SUSQUEHANNA - UNIT 2

The following three questions are addressed for each of the proposed changes:

FIGURE 3.2.1-1

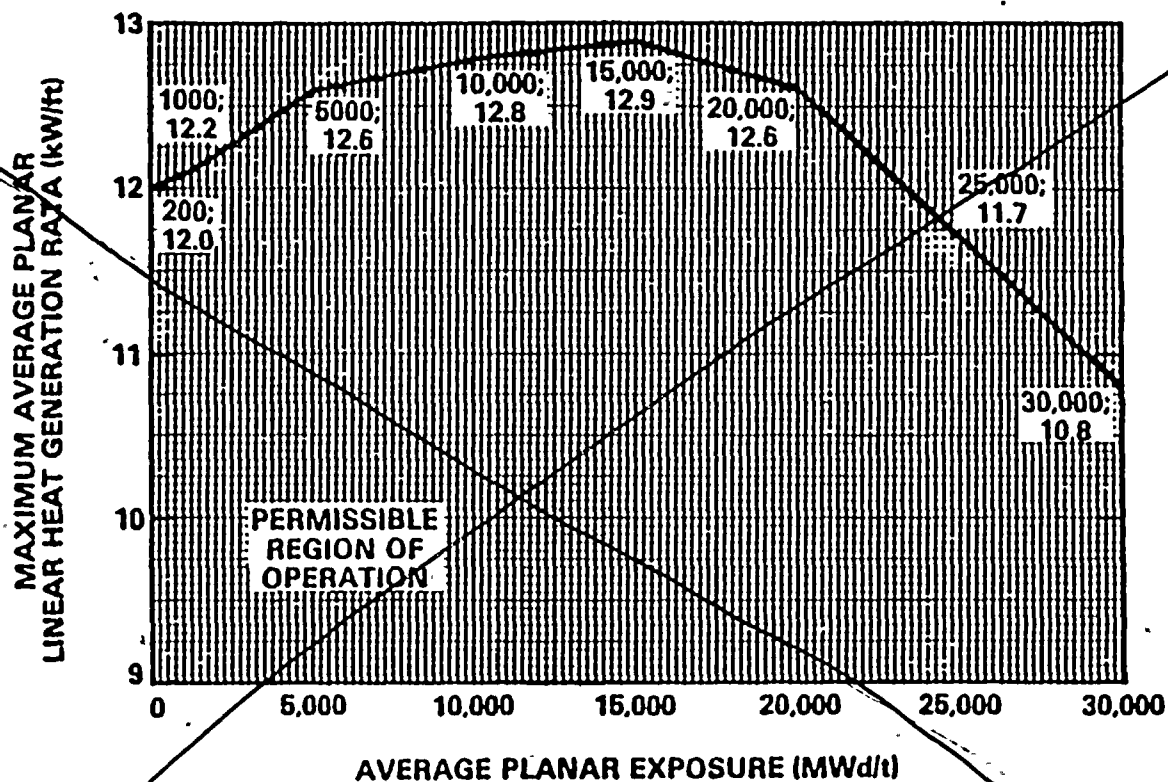
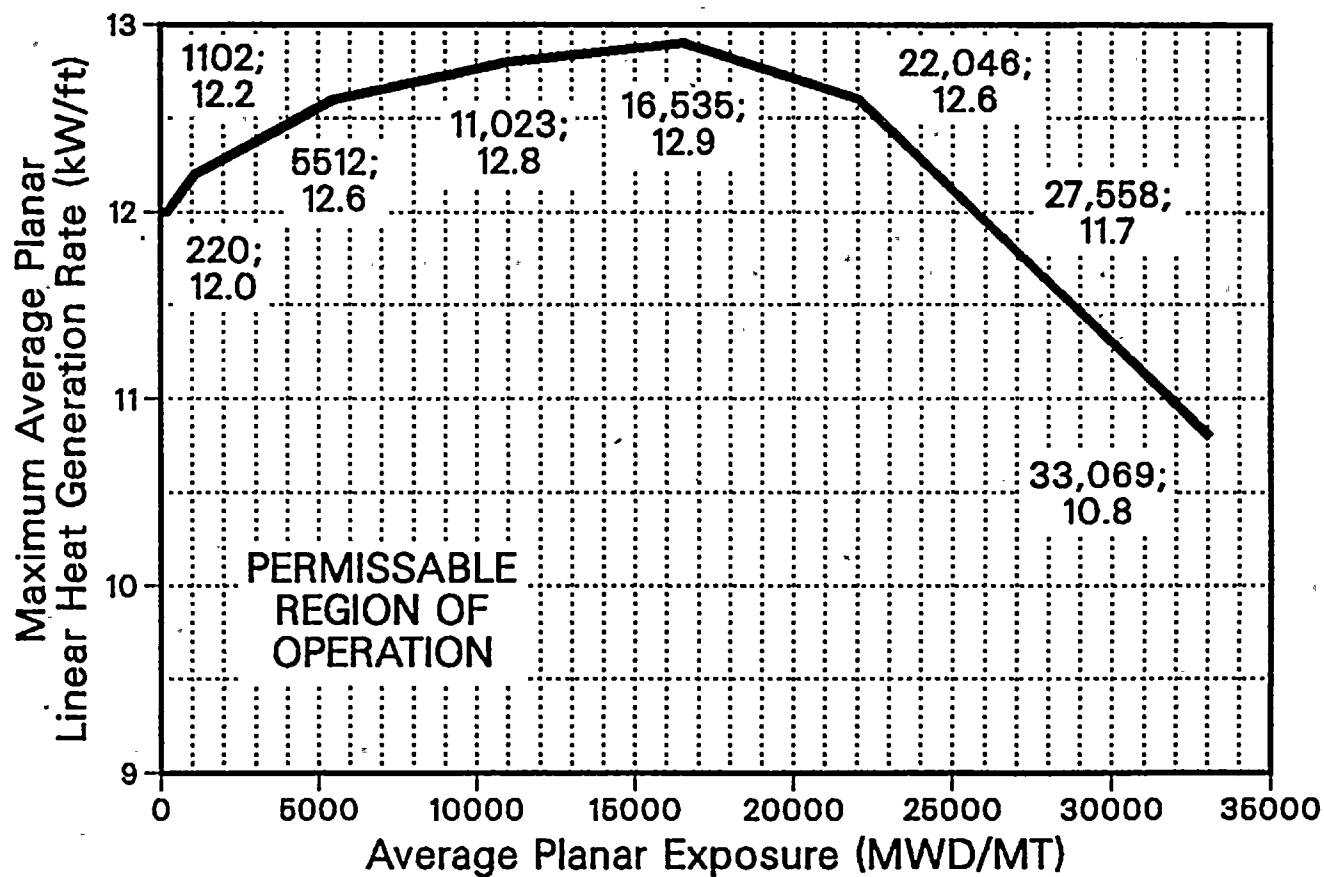
Replace with new
Figure 3.2.1-1

- I. No. Except for the new XN-1 fuel limits, each of the above changes are administrative in nature. For the average bundle exposure definition, this was previously discussed (see Definition 1.2). Figures 3.2.1-1 and 3.2.1-2 for GE fuel have simply been altered due to the conversion of the abscissa units from MWD/t to MWD/MT for consistency with the new Figure 3.2.1-3. The current Figure 3.2.1-3 has been deleted since the .711% enriched fuel it applied to will not be part of the Cycle 2 core.

FIGURE 3.2.1-2

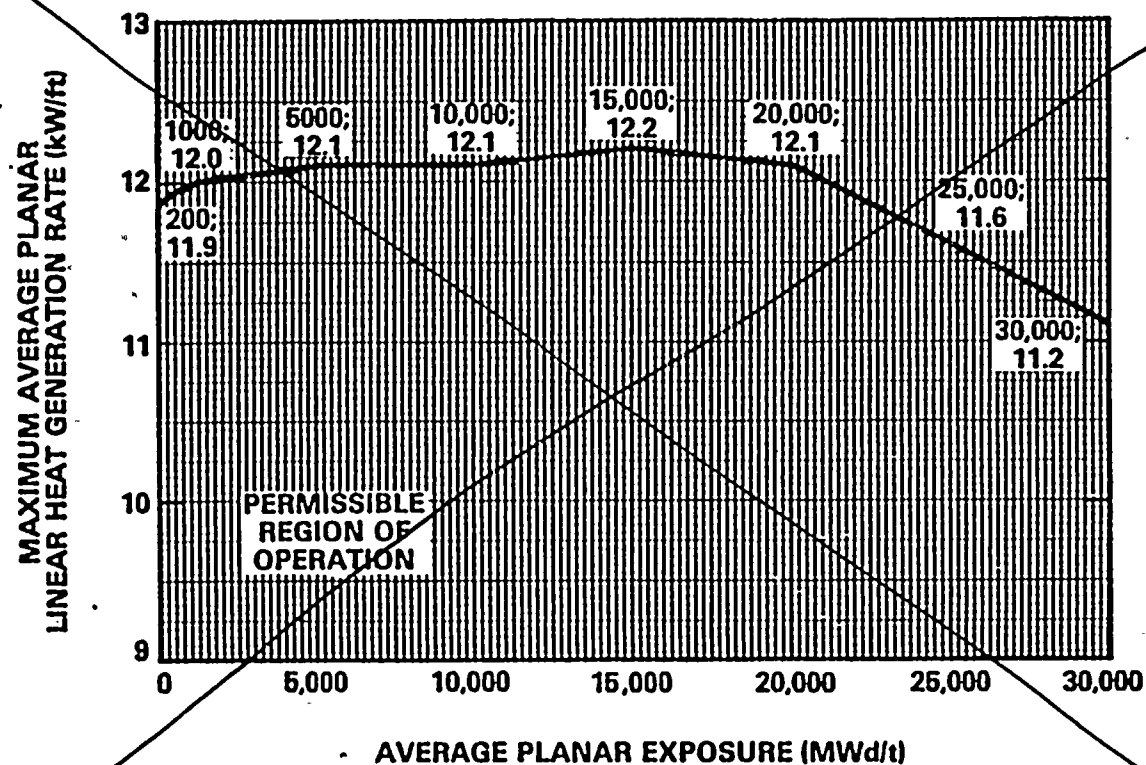
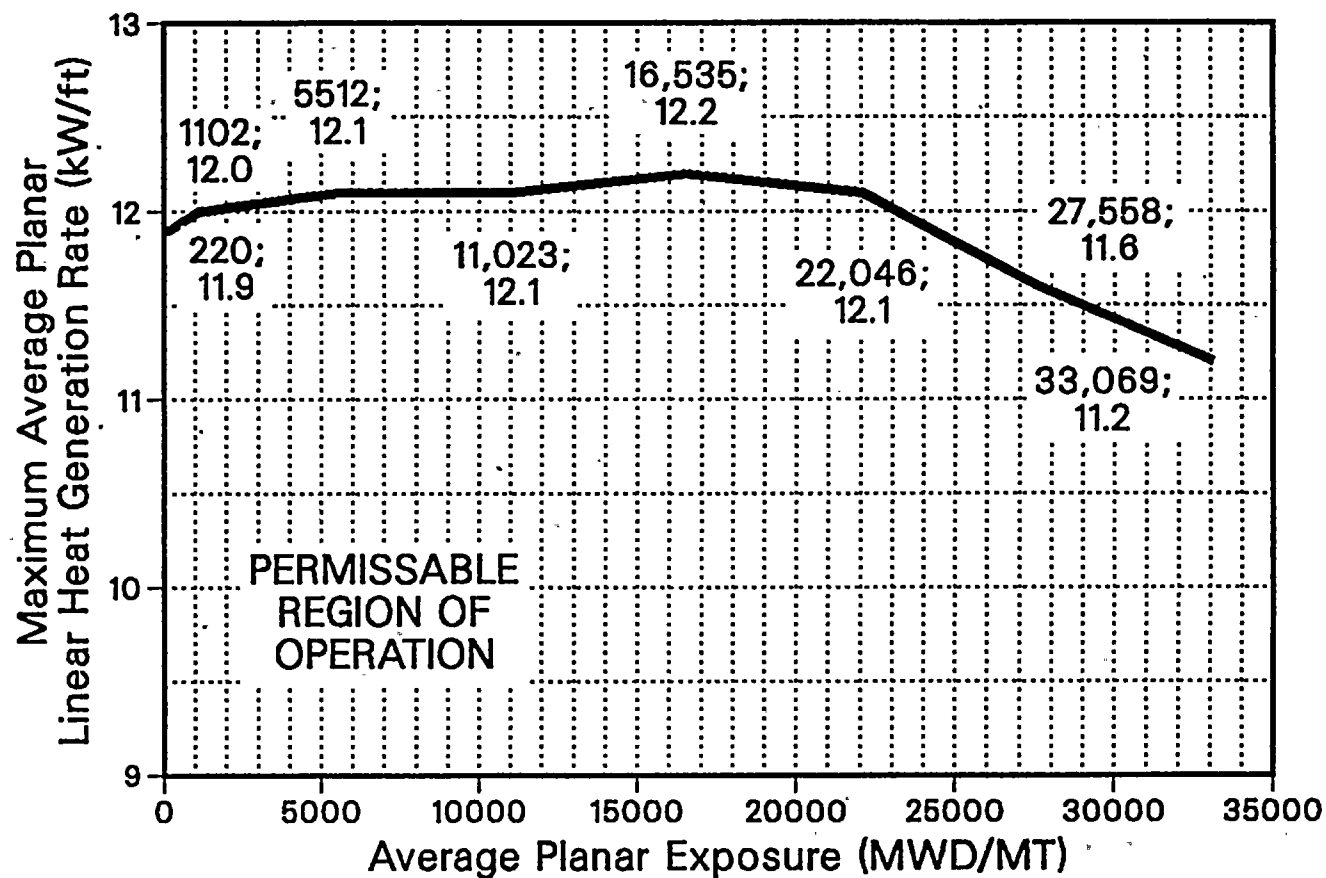
Replace with new figure 3.2.1-2

FIGURE 3.2.1-3

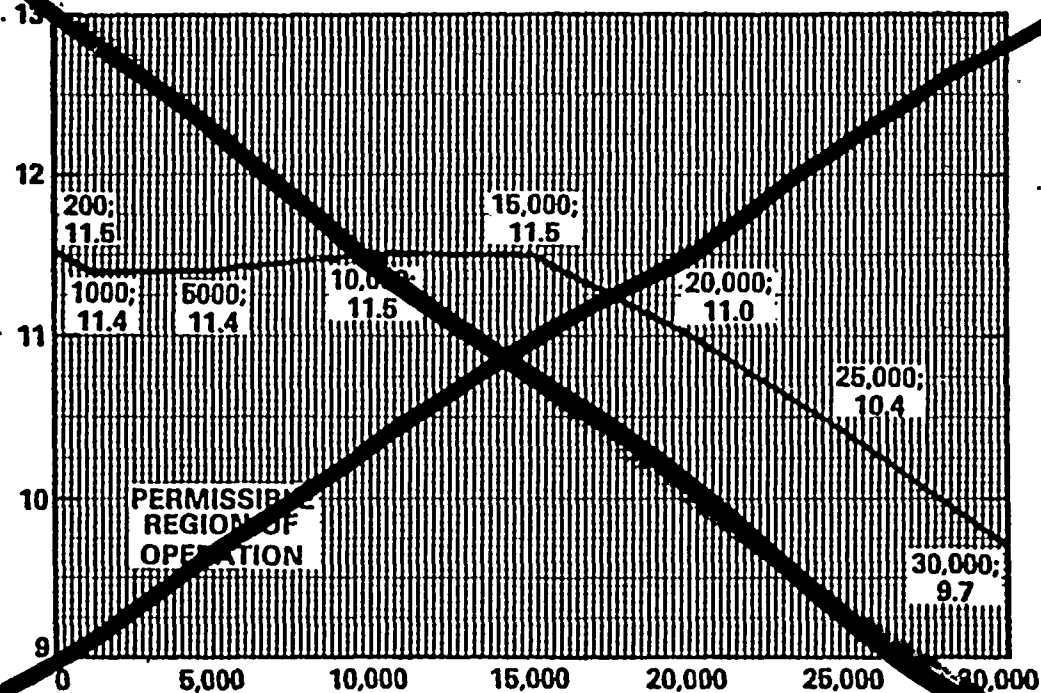
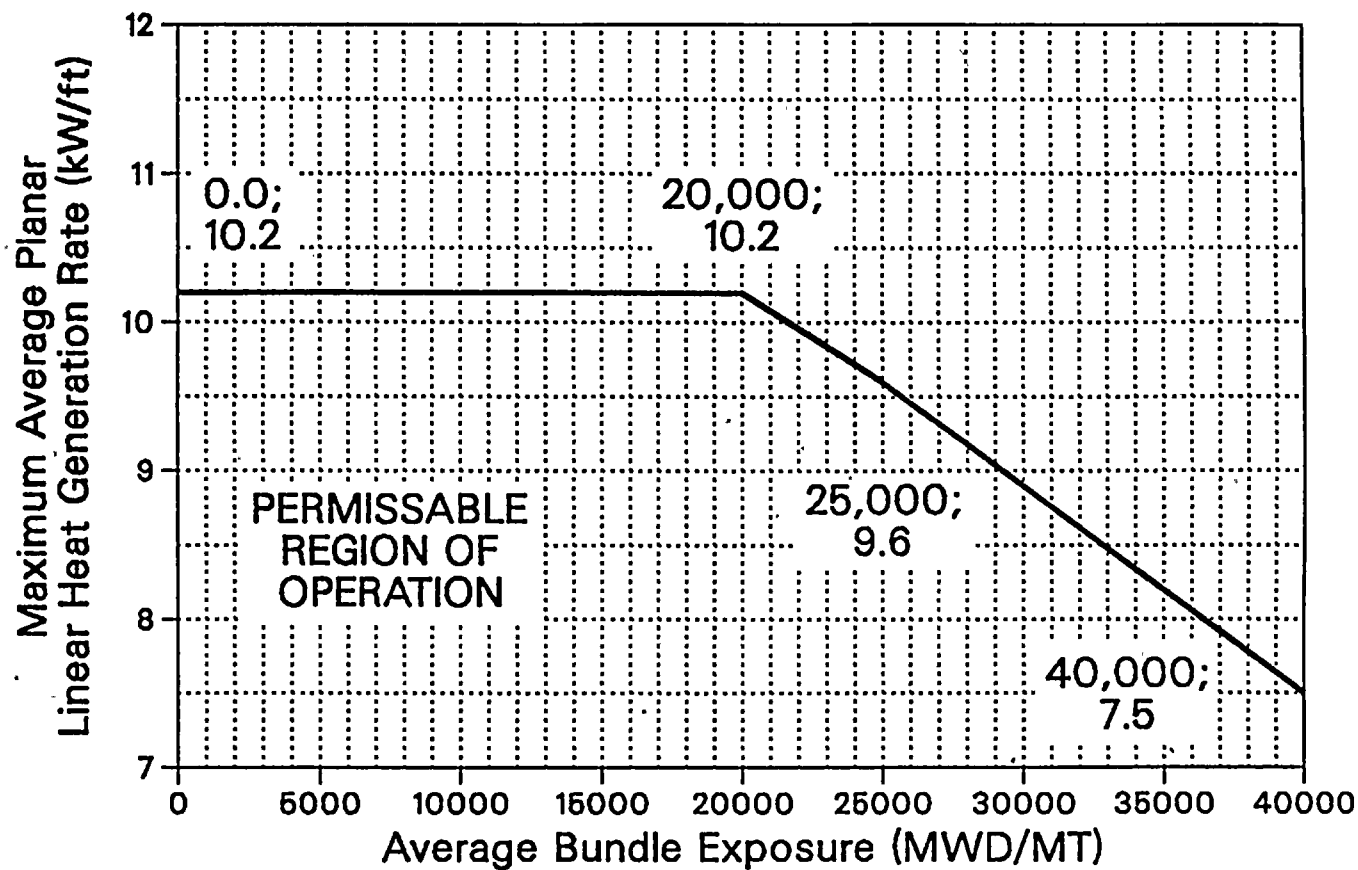
REPLACE w/
NEW FIGURE 3.2.1-3

New Figure 3.2.1-3 illustrates the MAPLHGR limits for XN-1 fuel. These limits are based upon an ENC analysis of the Loss of Coolant Accident (LOCA) as described in XN-NF-86-60 (attached). Based on this analysis, operation within the proposed MAPLHGR limits will ensure that the Peak Cladding Temperature (PCT) remains below 2200°F, local Zr-H₂O reaction remains below 17%, and core-wide hydrogen production remains below 1% for the limiting LOCA as required by 10CFR50.

LINEAR HEAT GENERATION RATE FOR APRM SETPOINTS
VERSUS AVERAGE PLANAR EXPOSURE
EXXON 9X9 FUEL
FIGURE 3.2.2-1

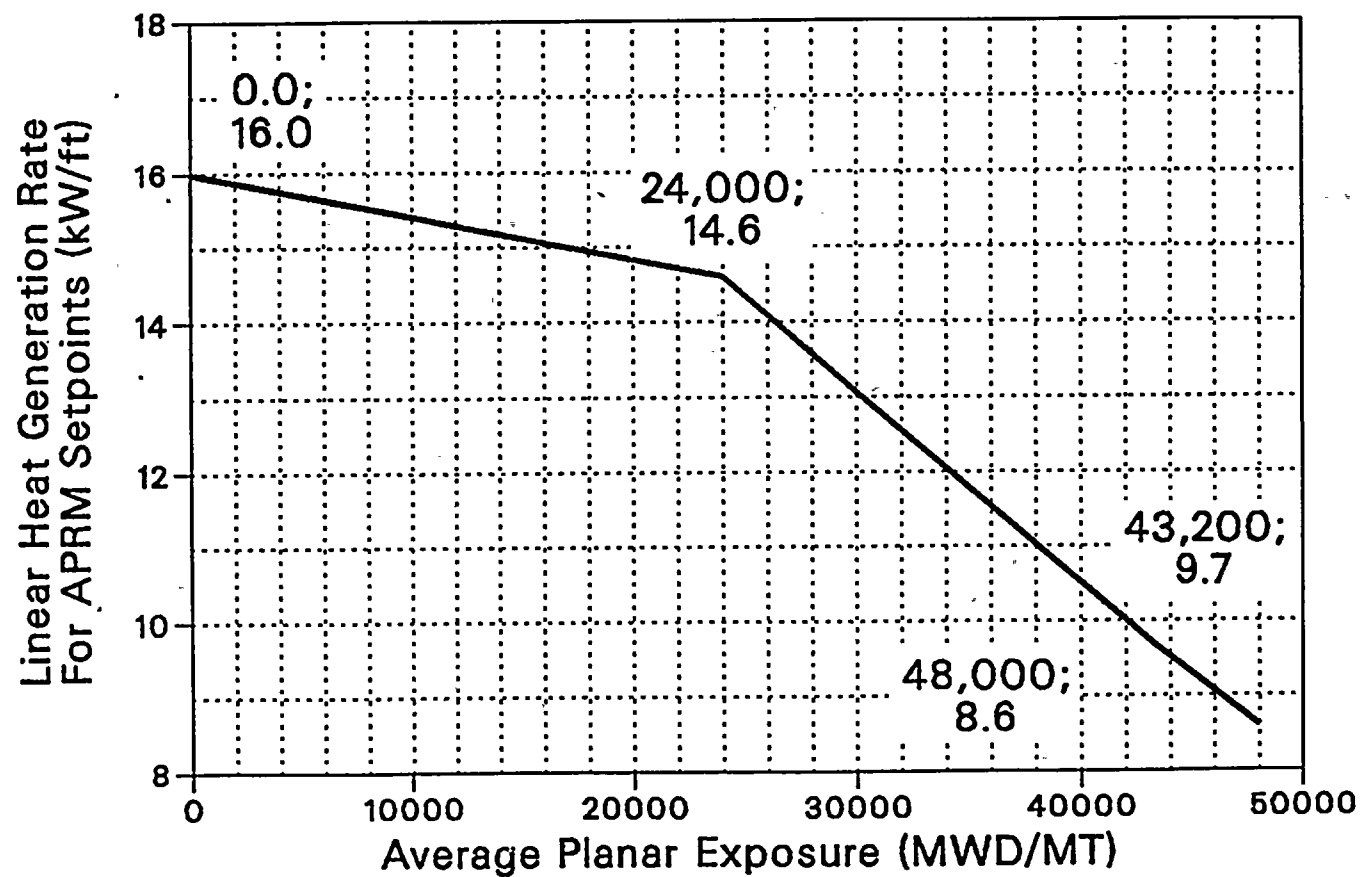
This specification has been changed to explicitly define T for GE fuel and for ENC fuel. Since for ENC fuel T is dependent on a transient-based LHGR, a new figure, 3.2.2-1, has been provided.

For ENC fuel, the T factor is modified by an exposure-dependent LHGR which is based on Exxon's "Protection Against Fuel Failure" (PAFF) line shown on Figure 3.4 of XN-NF-85-67, Revision 1. This LHGR is

provided in new Figure 3.2.2-1, which corresponds to the ratio of PAFF/1.2. Under this limit, cladding and fuel integrity are protected during anticipated operational occurrences (AOO's), including an overpower condition for transients initiated from partial power. Therefore, this change will ensure fuel design limits are not violated.

FIGURE 3.2.3-1a

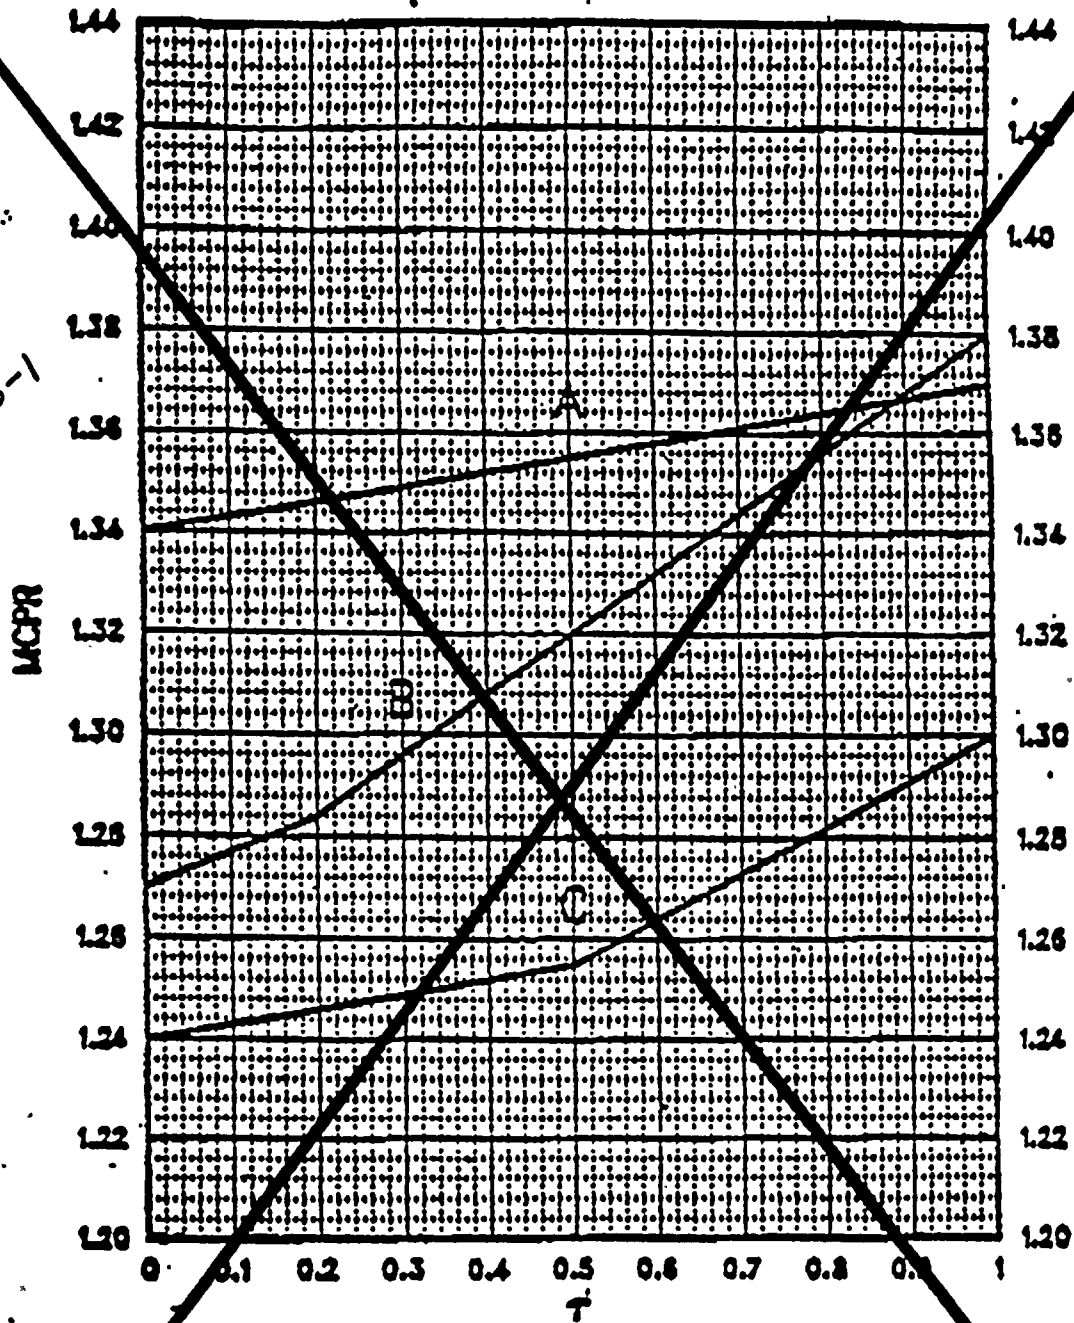
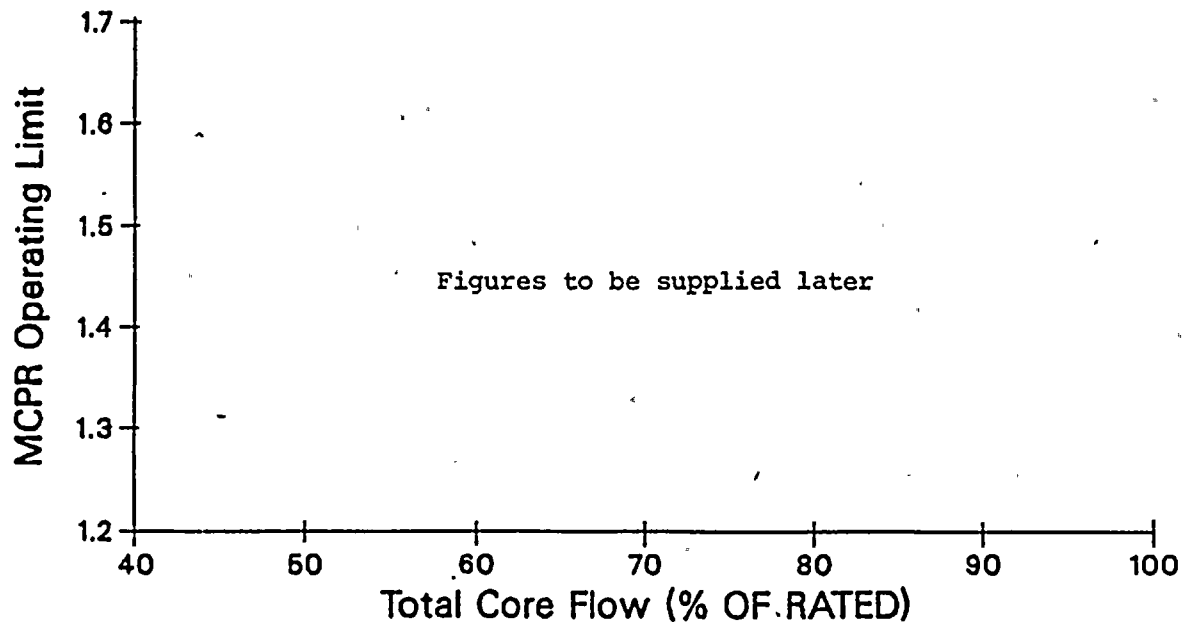
REPLACE
w/ FIGURE 3.2.3-1

When the less operationally limiting Rod Block Monitoring trip setpoint (.66W + 42% from Table 3.3.6-2) is used, the more limiting MCPR curve Figure 3.2.3-1b is applicable due to a larger delta MCPR from the ~~limiting~~ Rod Withdrawal Error (RWE) transient. Figure 3.2.3-1a is applicable when the Rod Block Monitor trip setpoint (.66W + 40% from Table 3.3.6-2) is used.
